Bid Addendum 03

Project: Maritime Museum Education Center,
Beaufort, NC – Construction Phase Services

Date: July 25, 2024

ADD ALTERNATE PLAN

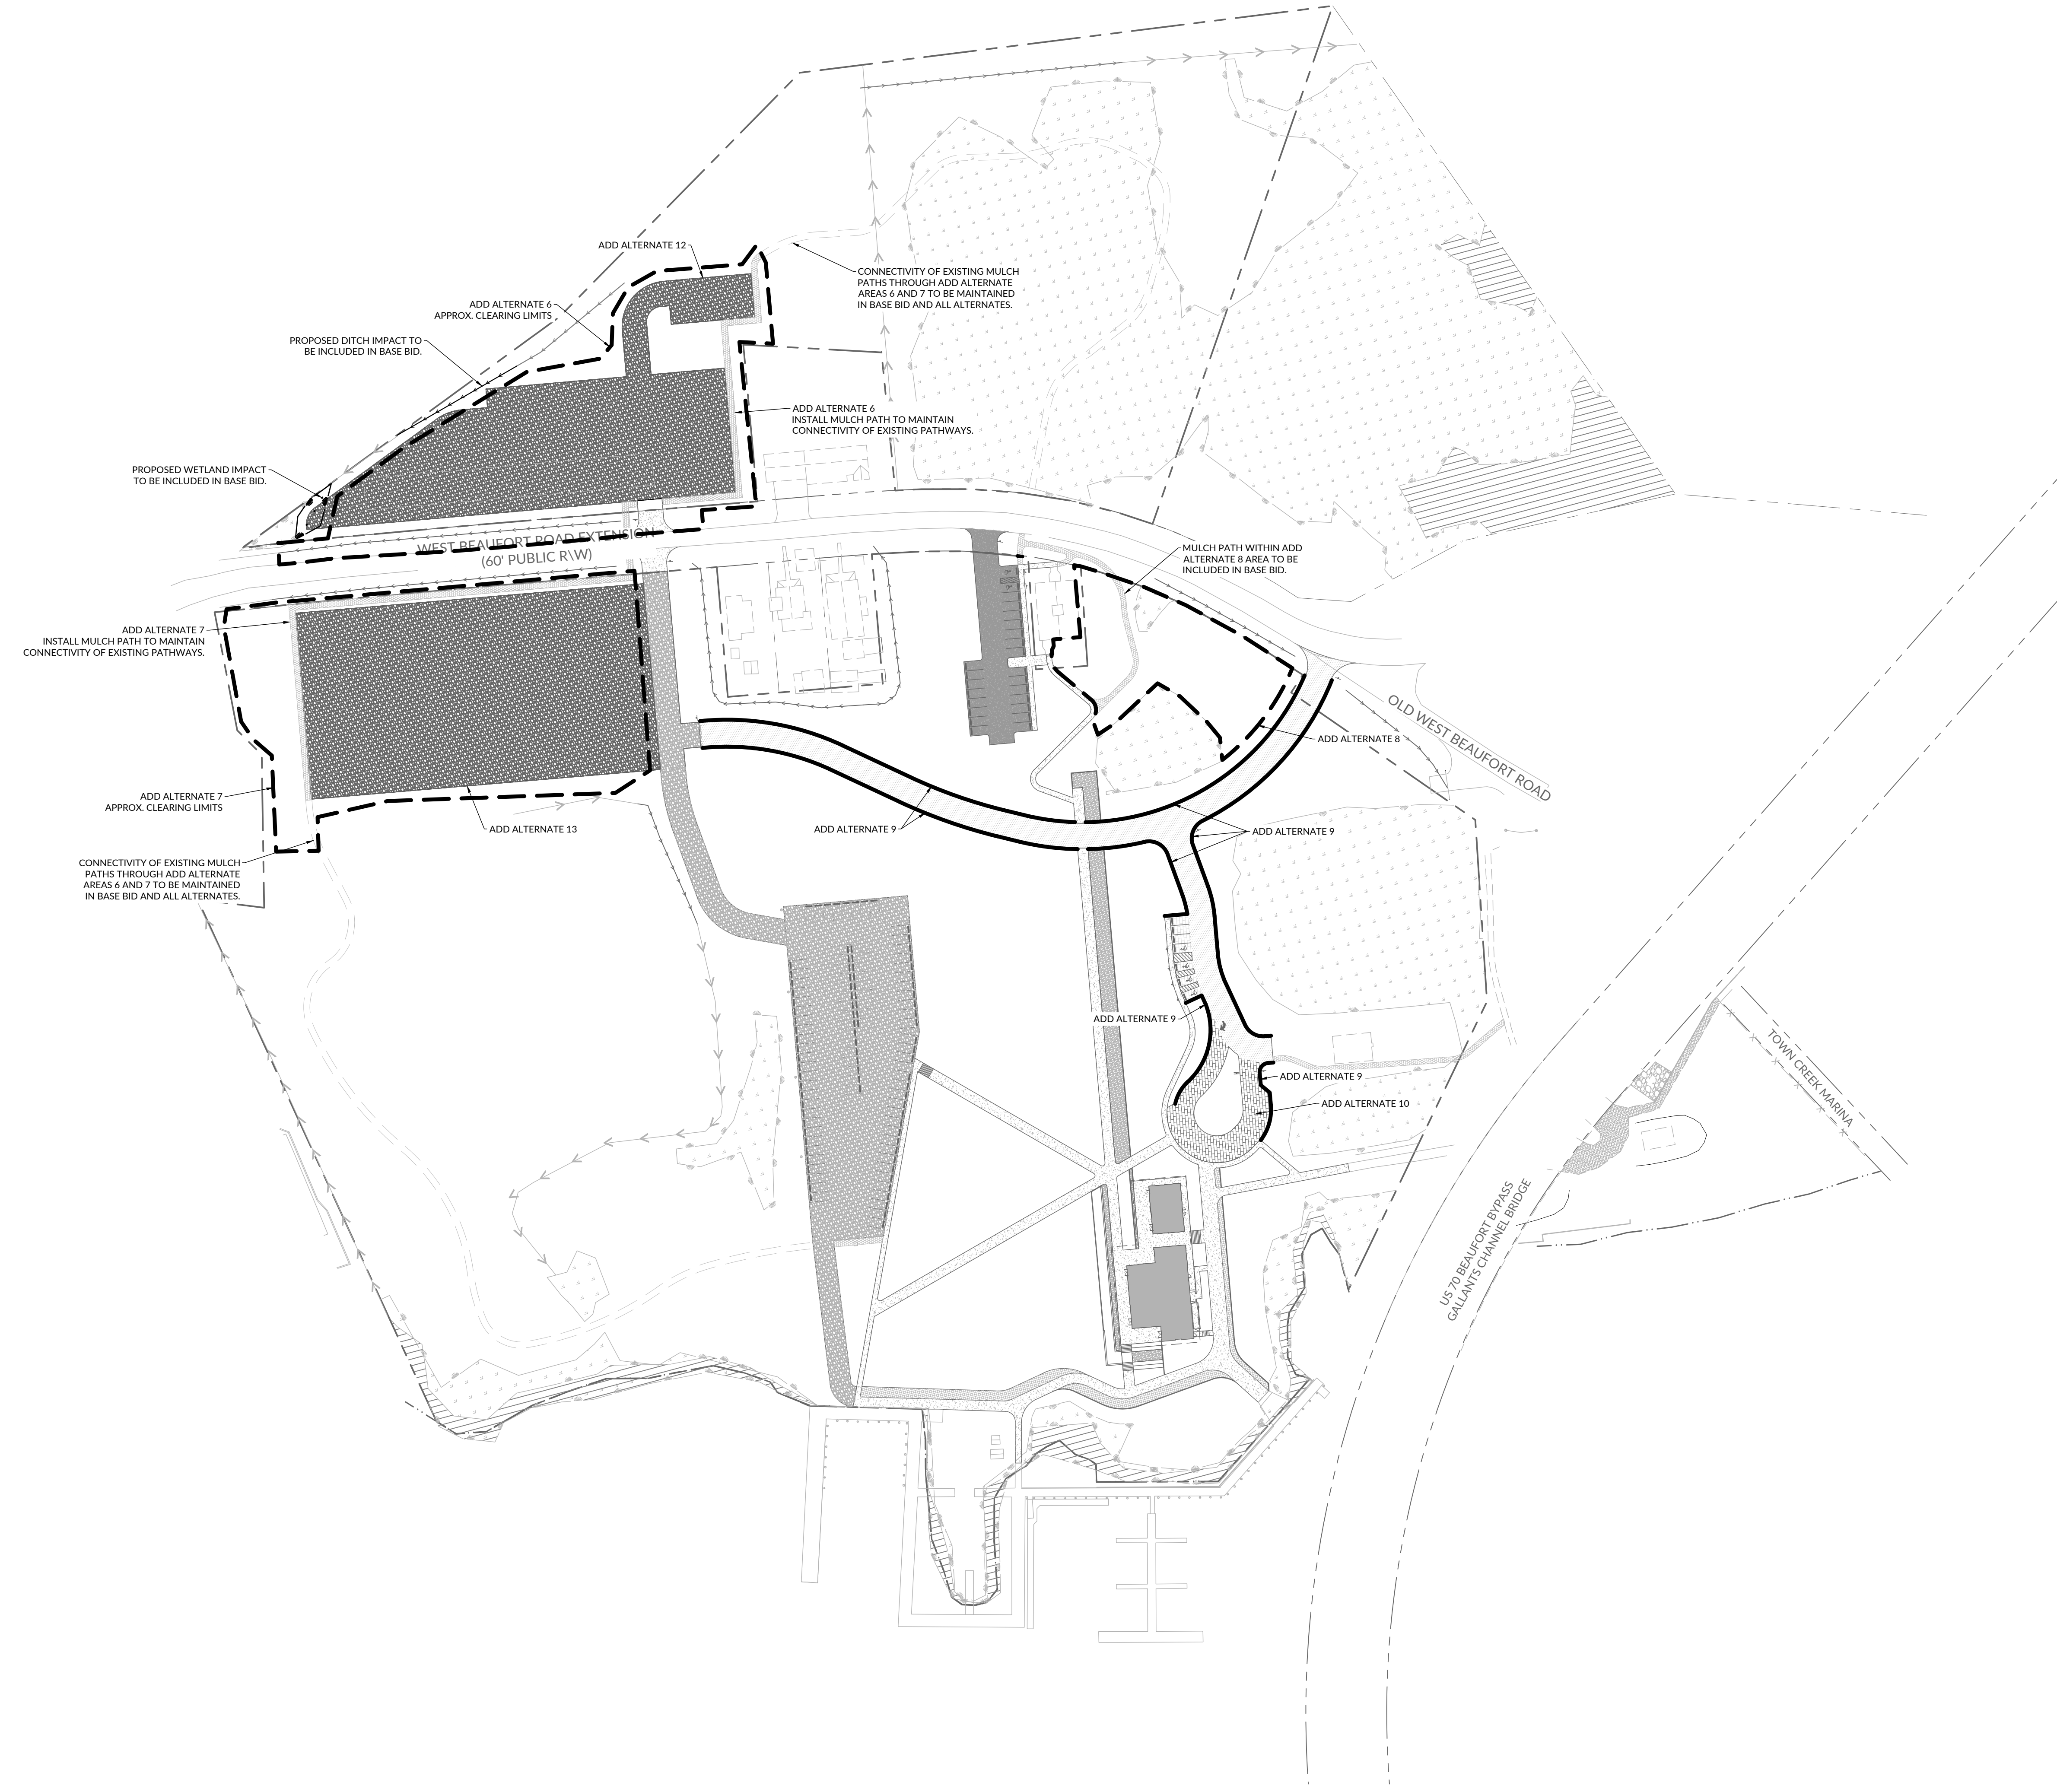
1. Sheet GI001:
 - a. Added Sheet C2.04 to Index
 - b. Removed reference to Sheet PS2.01 from Index
2. Sheet C0.00:
 - a. Added Sheet C2.04 to Index
 - b. Removed reference to Sheet PS2.01 from Index
3. Added Sheet C2.04 – ADD ALTERNATES PLAN

- a. RESPONSE: Alternate #5 has been revised to NOT USED, and Alternates #12 and #13 have been added to break up the graveled area into north and south sections that correspond to the graded areas included in Alternates #6 and #7, respectively. Civil Sheet C2.04 ADD ALTERNATES has been added, and all Civil related Alternates have been labeled therein so that the base bid is clearly defined. See also PROJECT MANUAL MODIFICATIONS and ATTACHMENTS of this Addendum.

ADD ALTERNATE 12
INSTALL GRAVEL AT OVERFLOW PARKING LOT NORTH OF WEST BEAUFORT ROAD EXTENSION.

ADD ALTERNATE 13
INSTALL GRAVEL AT OVERFLOW PARKING LOT WEST OF FIRE ACCESS DRIVEWAY.
